FLIGHT 93 NATIONAL MEMORIAL INTERNATIONAL DESIGN COMPETITION

STAGE II JURY REPORT

09/07/05

CRESCENT OF EMBRACE

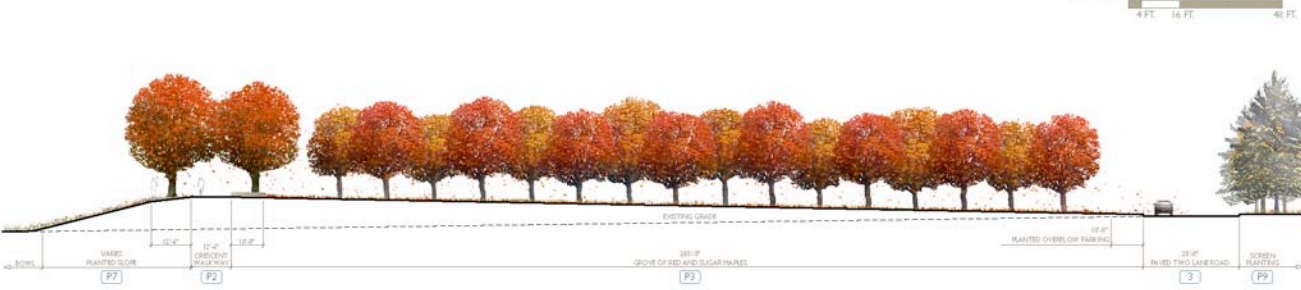
5. Words and Labels: Consider the interpretation and impact of words within the context of this event. The “Crescent” should be referred to as the “circle” or “arc” or other words that are not tied to specific religious iconography.
6. Temporary Memorial: Recognizing the importance of this element as an immediate and appropriate memorial, the Temporary Memorial should be retained and maintained as long as practical.
7. Confirmation of Design: The Stage II Jury requests that at an appropriate time, the Jury (or representative group of Jury members) be assembled to review the design evolution of the Memorial. This meeting would be an opportunity for the design team to explain the design evolution to date and the design team’s response to the Jury’s comments and issues. This meeting would be at the midpoint of the schematic design phase of the professional design contract.

TOWER OF VOICES

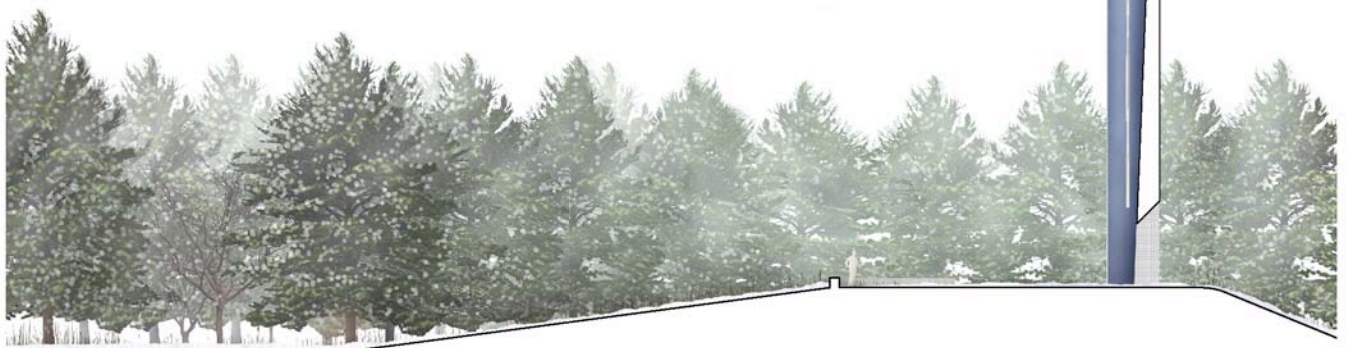
1. Tower of Voices: Consider the sound impact of the tower chimes on near-by neighbors.
2. Draglines: Retain the draglines and provide a stopping place at the ridge of the bowl for visitors to view the entire site.
3. Articulation of History: Integrate the timeline of September 11 to inform the visitor. This is assumed to be accomplished within the Visitor Center and included in its interpretive planning.
4. Interpretive Planning: The Visitor Center is critical and central to the Memorial Expression; therefore the interpretive planning and exhibits should be accomplished simultaneously with the on-going design development of the Memorial.
